DRAWING AMENDMENTS

BEST AVAILABLE COPY**REMARKS**

TITLE: LETTER COVER
 INVENTOR: JYCKE V. PAAVILA
 SER. NO. 10/802,337

Fig-2

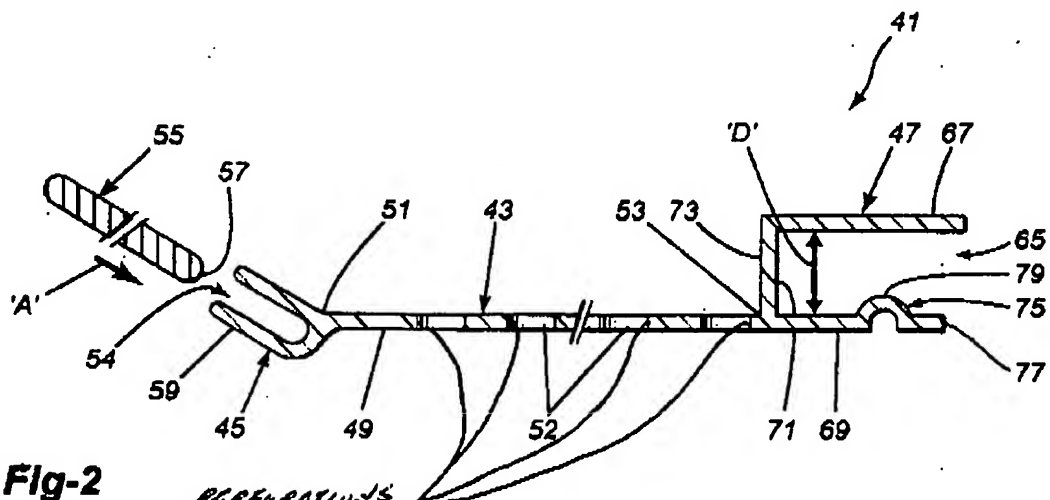
Fig. 2 has been amended to show perforations 52 in the panel of the gutter cover. A fresh sheet incorporating the change is attached along with a marked up sheet showing the change.

In the drawings, amend Fig. 2 to show perforations 52. See DRAWING AMENDMENTS.

PERFORATIONS
 '52' ADDED
 * REF. CHARACTER
 '52' ADDED
